Well Name: EAGLE 34 FEDERAL	Well Location: T17S / R27E / SEC 34 / NESE /	County or Parish/State: EDDY / NM
Well Number: 30	Type of Well: OIL WELL	Allottee or Tribe Name:
Lease Number: NMLC064050A	Unit or CA Name:	Unit or CA Number:
US Well Number: 300153173500S1	Well Status: Producing Oil Well	Operator: REDWOOD OPERATING LLC

### Notice of Intent

Type of Action Plug and Abandonment

## PLUG AND ABANDONMENT CONDITIONS OF APPROVAL

<b>OPERATOR'S NAME:</b>	Redwood Operating LLC
<b>LEASE NO.:</b>	NMLC064050A
<b>WELL NAME &amp; NO.:</b>	Eagle 34 Federal 30
<b>US Well Number:</b>	3001531735
<b>LOCATION:</b>	Section 34, T.17 S., R.27 E., NMPM
<b>COUNTY:</b>	Eddy County, New Mexico

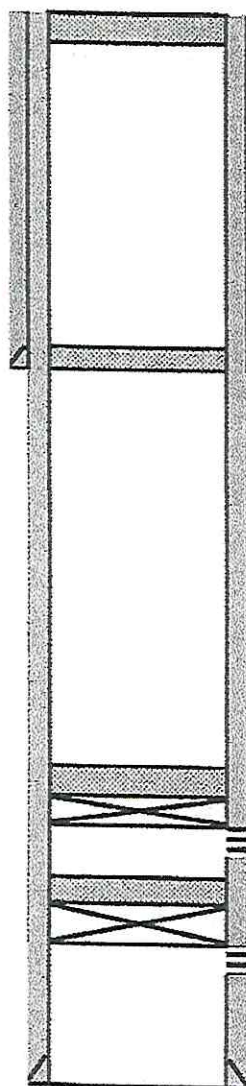
1. Set 5 1/2" CIBP @ 2620'. ~~Dump bail 35'~~ or spot 25 sx cmt @ 2620-2420'. *WOC & TAG*
2. Set 5 1/2" CIBP @ 1860'. Circ hole w/ MLF. Pressure test csg. Spot 25 sx cmt @ 1860-1660'.
3. Spot 25 sx cmt @ 1262-1060'. WOC & Tag (8 5/8" shoe)
4. Spot 25 sx cmt @ 200' to surface.
5. Cut off well head, verify cmt to surface, weld on Dry Hole Marker.
